The Old Power Station

Proposed Scheme Amendments
January 2024 (updated March 2024)

Railway Warehouse (Block A)

Schedule of Amendments

448.LA.101 F448.LA.101 N

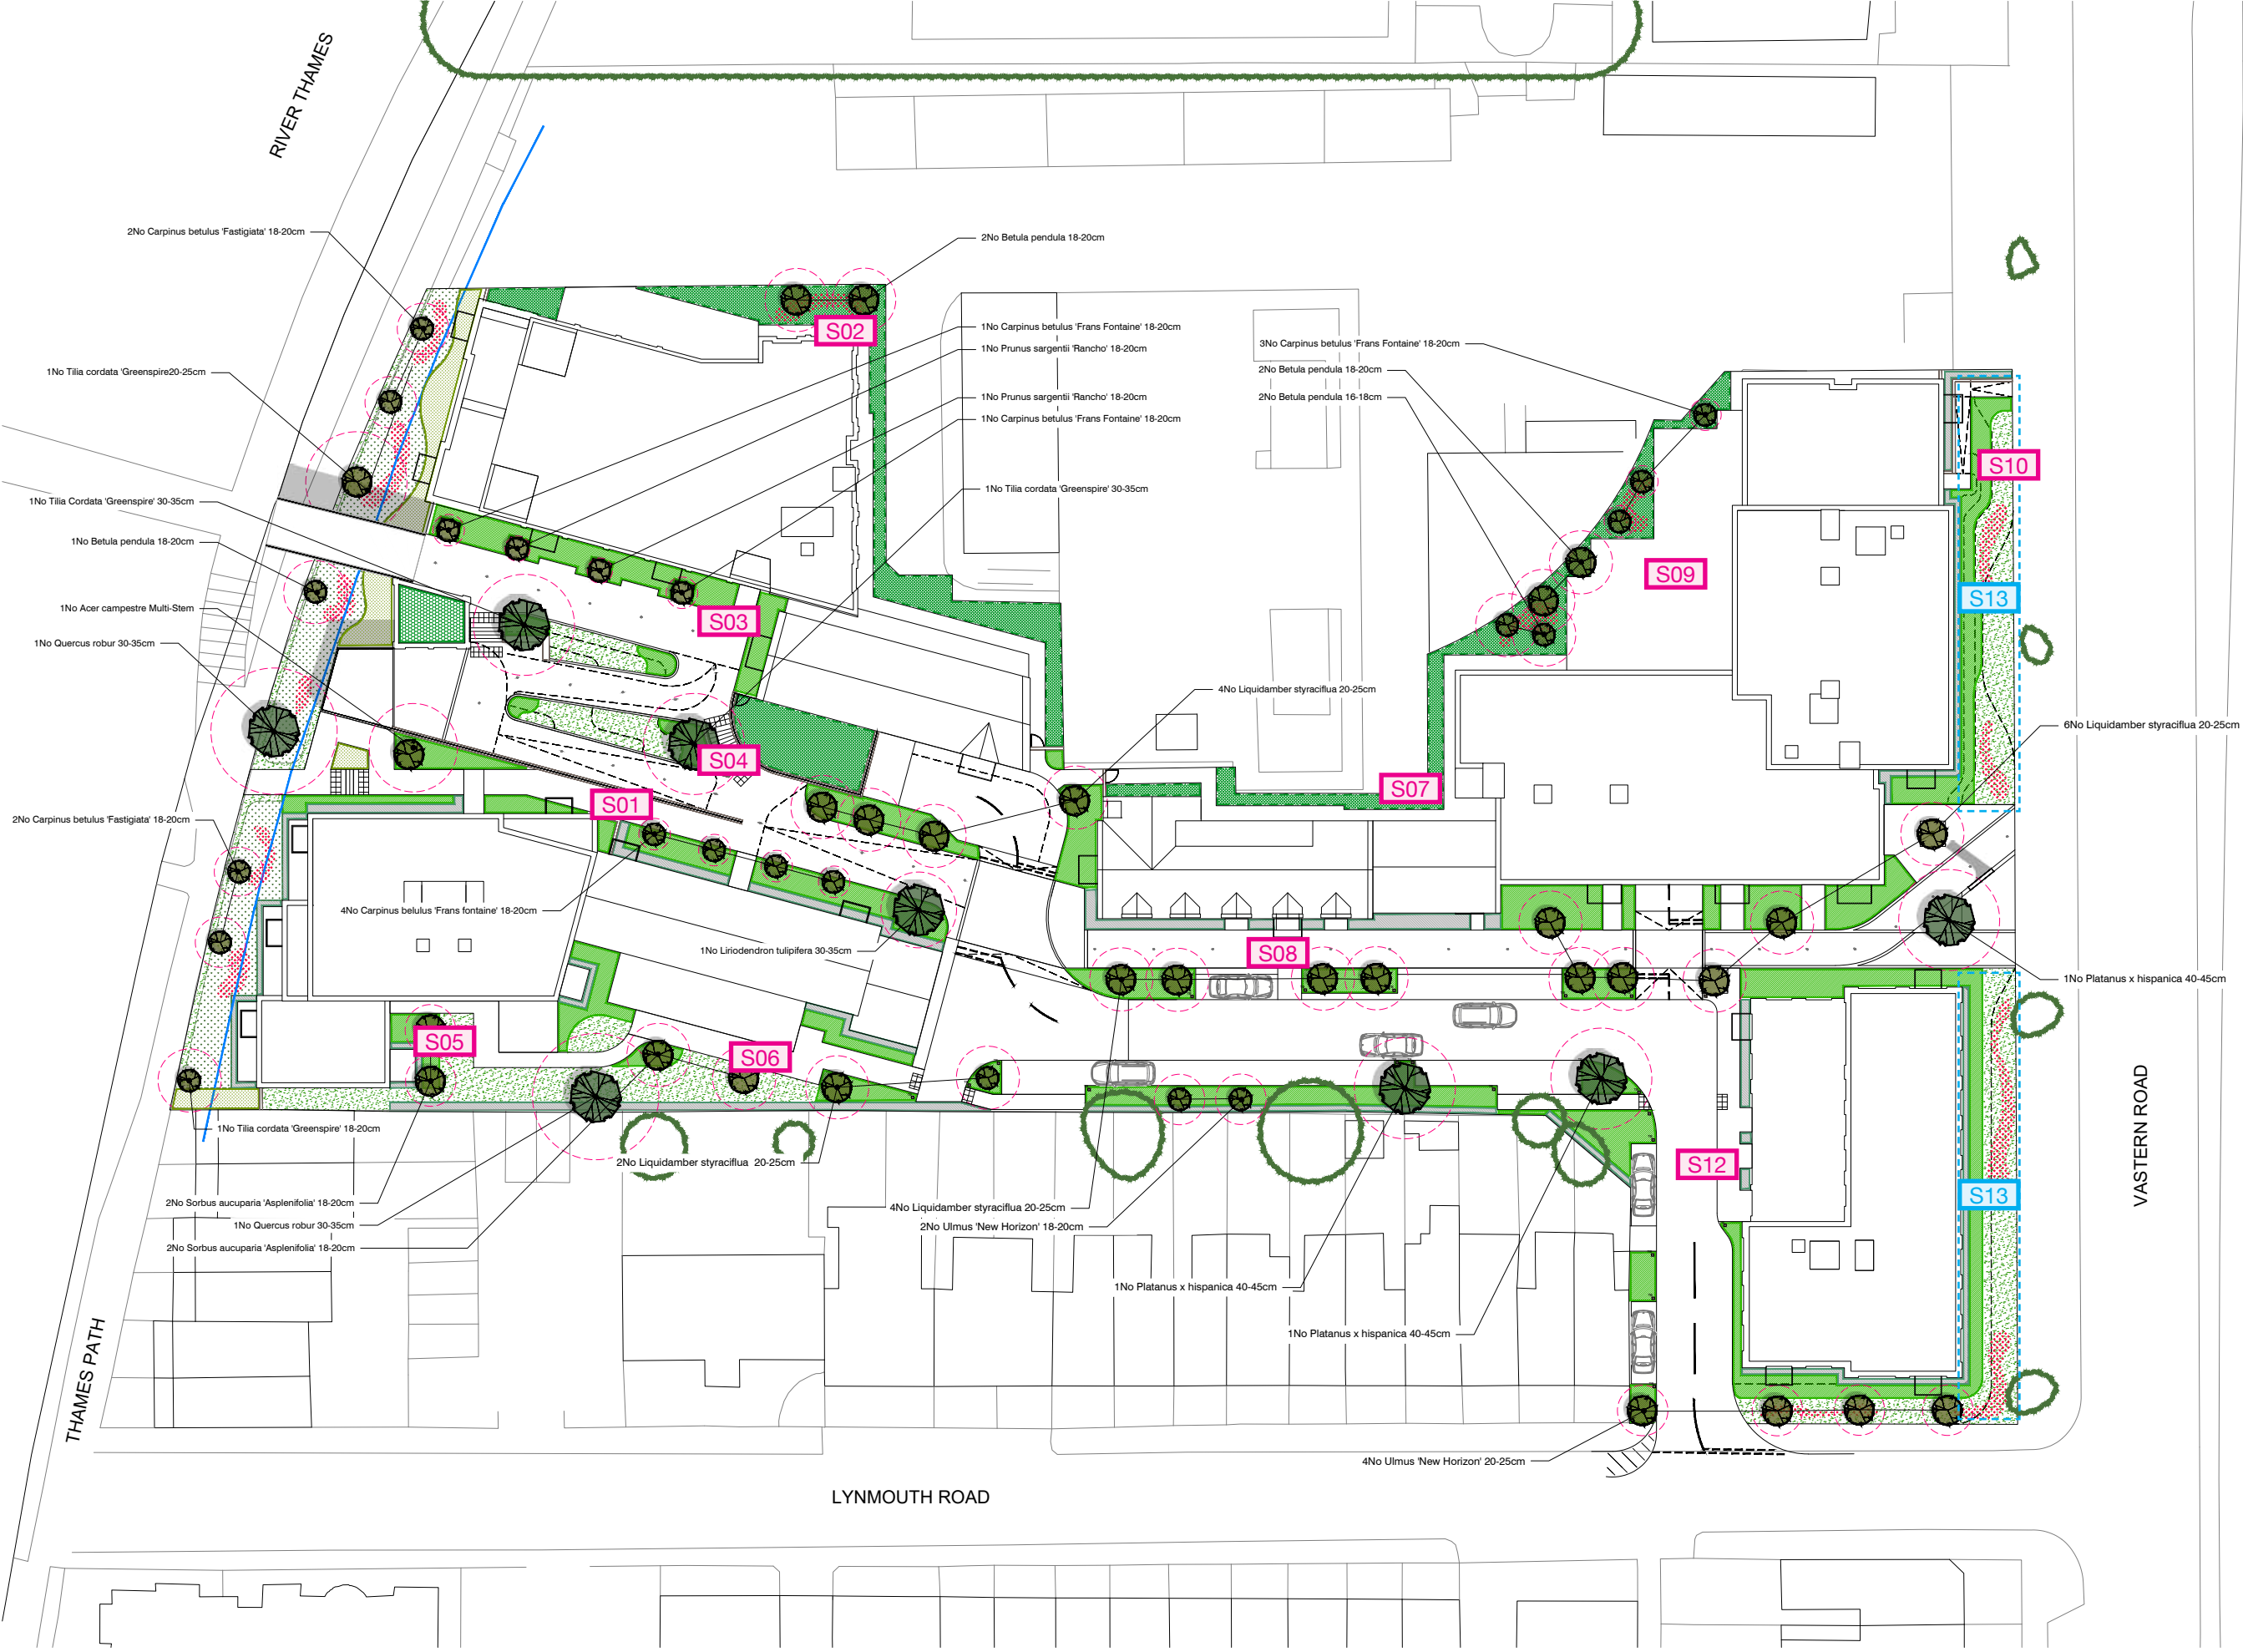
Reference	Description	Justification
S01	Adjustments to the towpath access.	Layout updated to reflect the approved towpath access plan.
S02	Continuation of footpath around south and east of Turbine Hall.	Footpath continued around the building to connect the revised fire escape locations to the alternative means of escape required from the undercroft area.
S03	Paving updated to entrance to Turbine Hall.	Paving area amended to reflect changes to the entrance door position and width.
S04	Steps updated.	Steps updated to reflect changes to the site layout to suit retaining wall within undercroft parking area. Blister paving added to the top and bottom of the steps. The revised stair position results in marginally greater soft landscape area to the north.
S05	Additional footpath connections added to rear of Christchurch Wharf.	Footpaths to the rear of the block amended to reflect the new fire escape locations. Soft landscaping updated to replace shrub planting with flowering lawn and an additional tree to provide more beneficial amenity and biodiversity.

S06	Footpath adjusted to refuse store at rear of Coal Drop Building.	Footpath updated to suit the revised refuse store door positions.
S07	Continuation of footpath around east of Goods Office and Goods Warehouse.	Footpath continued around the building to connect the revised fire escape locations and cycle store access.
S08	Adjustment to parking and landscape along central street.	Adjustements to the hard and soft landscape to allow direct access to the new sub station within Goods Office.
S09	Parking area and landscape to Good Warehouse amended.	4no parking spaces relocated to reflect changes to the undercroft elements through the alterations to plant room requirements to Goods Warehouse. Landscape adjusted to suit.
S10	Additional footpath onto Vastern Road.	Footpath added to the front of the block to reflect the fire escape location from the second stair core. See S13 for changes to planting.

S11	OMITTED - Reverted to approved layout.	n/a
S12	Paving updated to ancillary areas to Railway Warehouse.	Connections to the ancillary spaces adjusted to reflect the door positions into the refuse and cycle stores. See S13 for changes to planting.
S13	Changes to planting along Vastern Road.	Further review of the existing culvert along Vastern Road shows limited planting depth above. A stronger planting bed has been provided against the buildings with flowering lawn between this and the back of footway, thereby maintaining a green edge to the site and increasing biodiversity.

448.PL.A.100

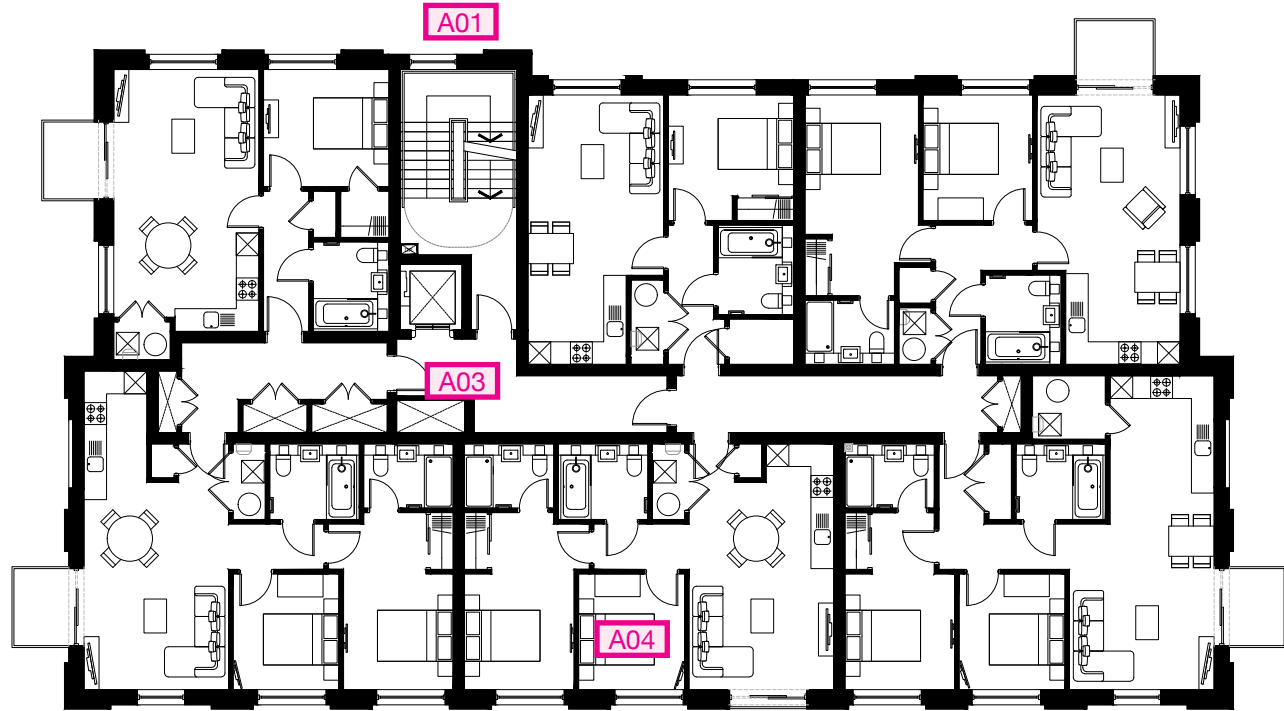
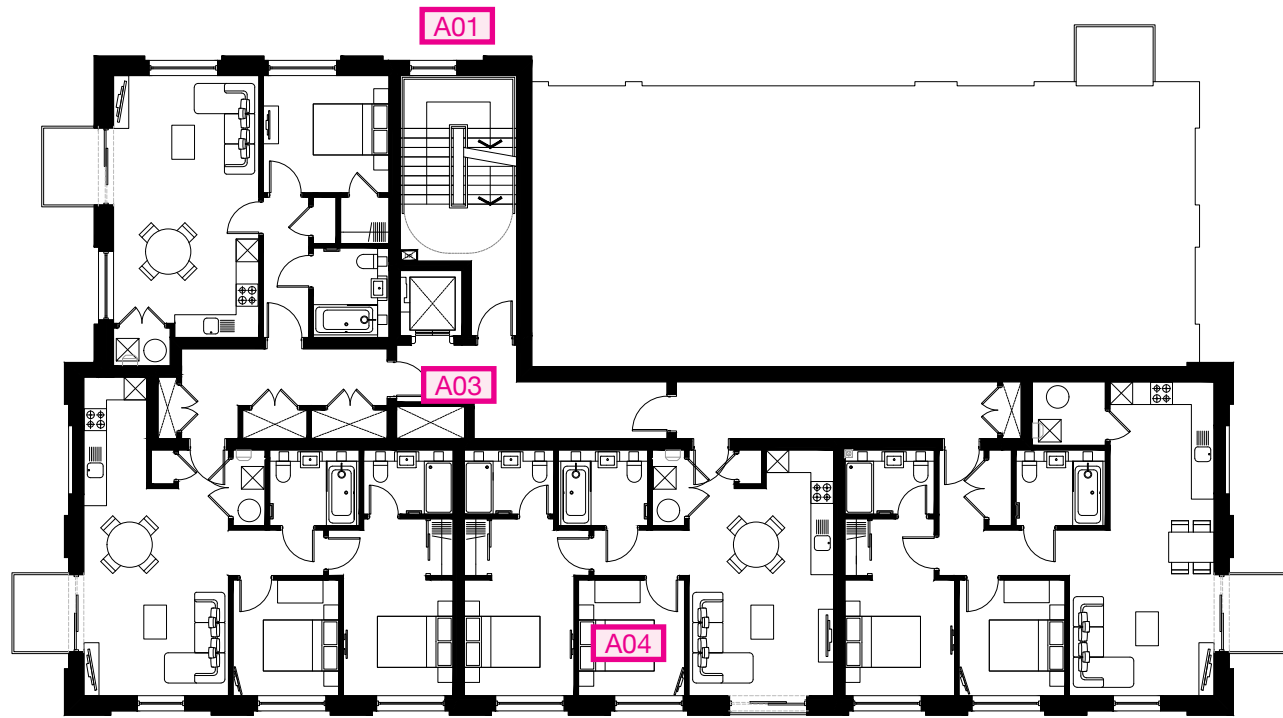
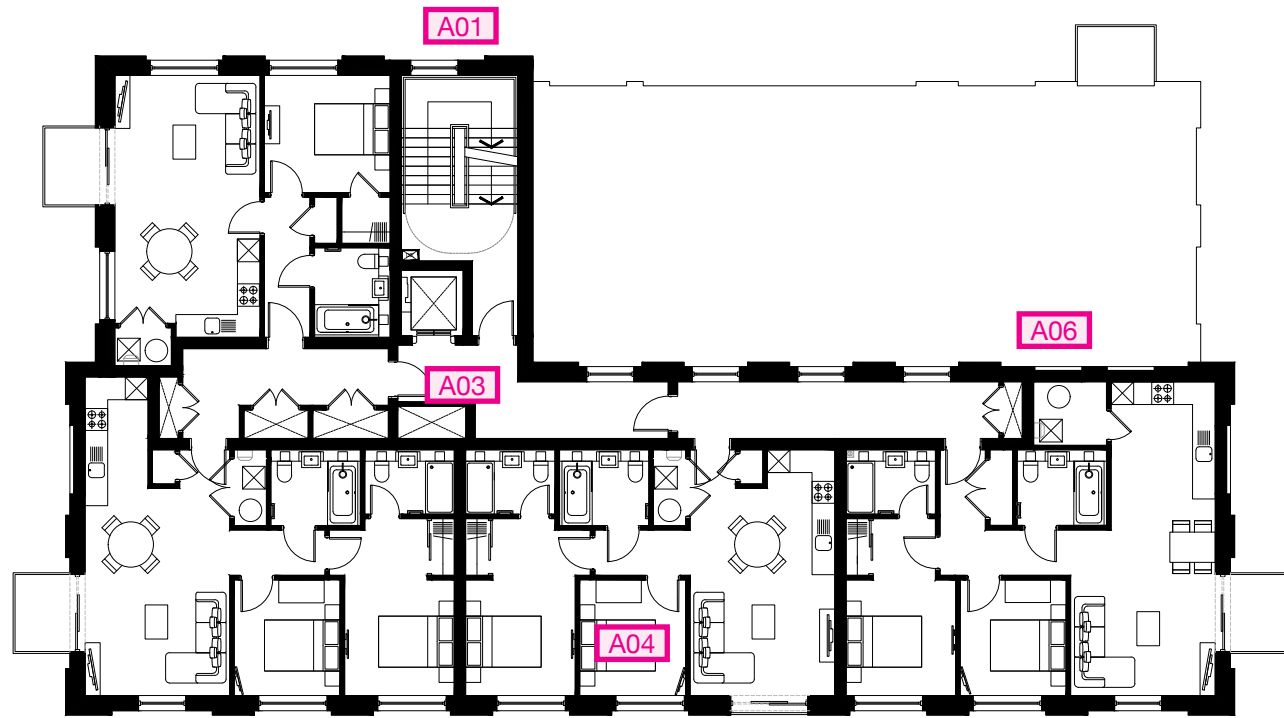
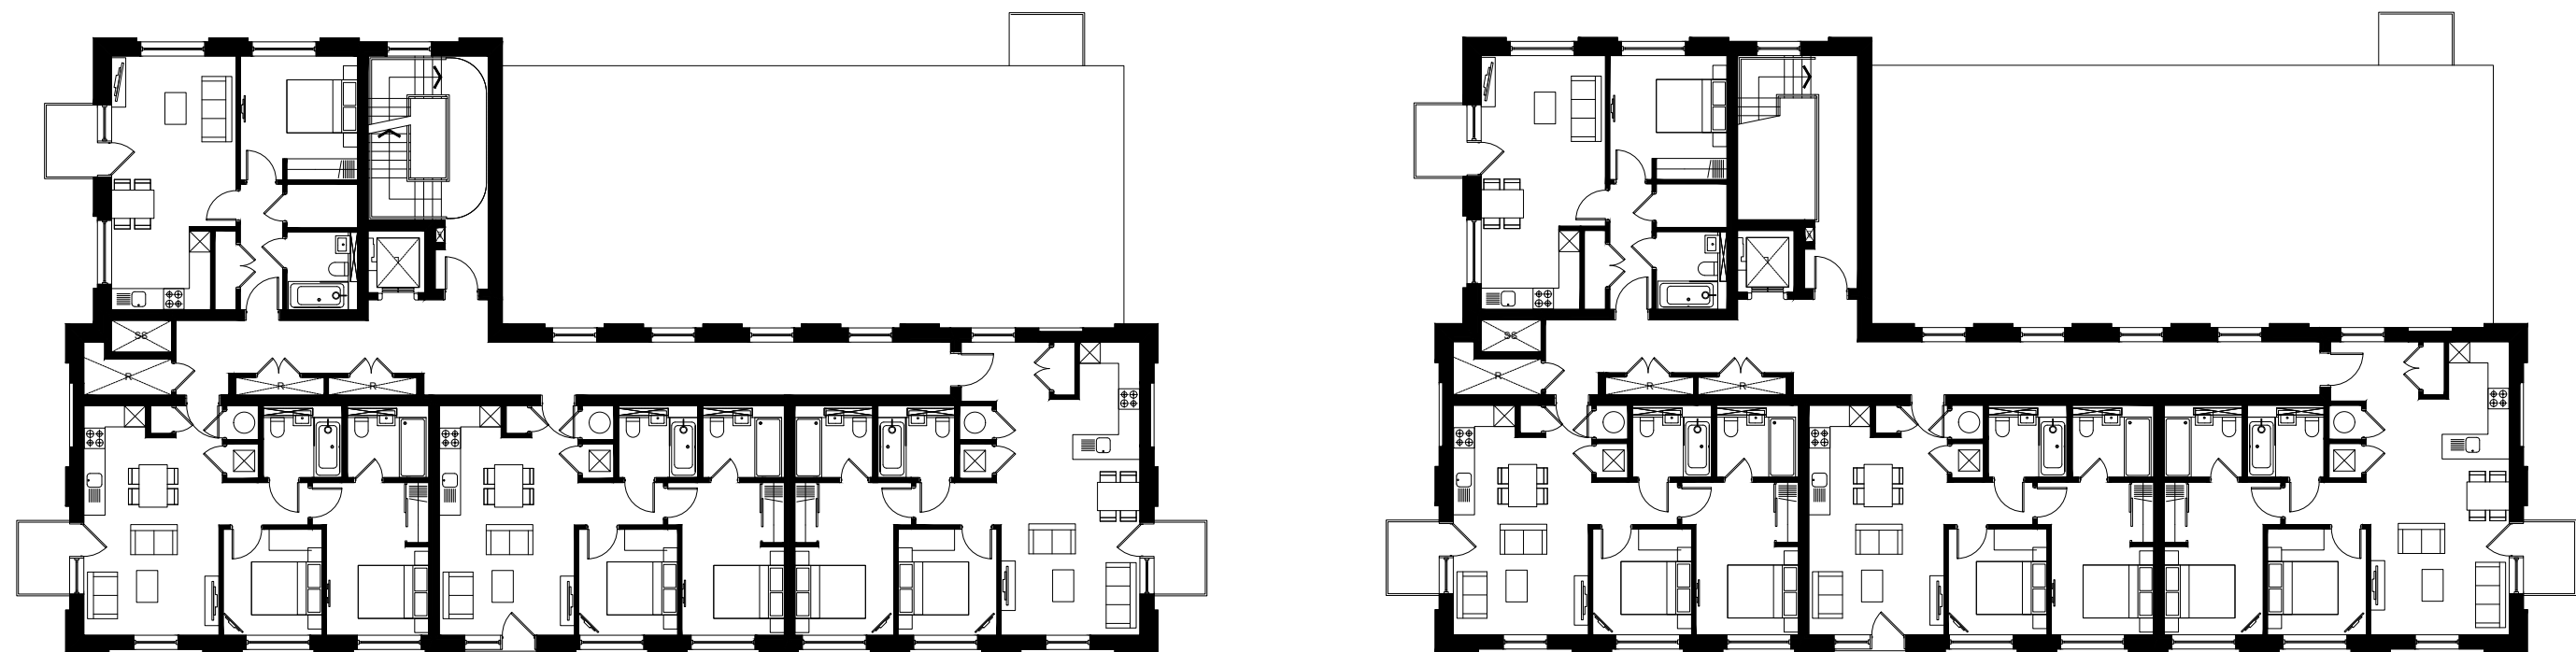
Reference	Description	Justification
A01	Stair configuration changed.	Stair width increased from 1200mm overall width to 1200mm between handrails to reflect fire regulation changes. Stair configuration amended to suit.
A02	Entrance door position set-back.	Entrance door moved inwards to suit changes in stair arrangement and subsequent relocation of stair escape door.
A03	Communal circulation arrangement changed with the introduction of a lift lobby and adjustment to the lengths of corridors serving apartment entrances.	Introduction of a lift lobby between the stairs and corridors with access to apartments in line with fire regulation changes. Corridors serving apartment entrances redesigned to limit distance from apartment entrance to the lift lobby to 7.5m max. to reflect fire regulations.
A04	Internal arrangement of apartment handed.	Internal apartment layout handed as entrance is relocated to sit within the communal corridor as required under fire regulations.

A05	Balcony position moved two bays to the right.	Balcony position changed to reflect internal arrangement changes set out in A04.
A06	Window changed to tax (bricked-in) opening.	Window to apartment hallway blocked due to relocation of apartment entrance to sit 7.5m from protected lift lobby to reflect fire regulation changes. Relocation of riser cupboard results in window being blocked.
A07	Lift and smoke shaft over-run positions changed and AOV introduced over stairs.	Lift position changed to suit A01 and A03, with smoke shaft position adjusted to suit fire regulations. AOV added to roof plan over stair position for clarity to reflect fire regulation requirements.
A08	Introduction of plant rooms.	Plant rooms introduced for LV switchgear and Emergency LV switchgear to provide dedicated emergency electrical supplies to each block.
A09	Refuse configuration updated.	Internal refuse store arrangement updated to suit feedback from waste officer.
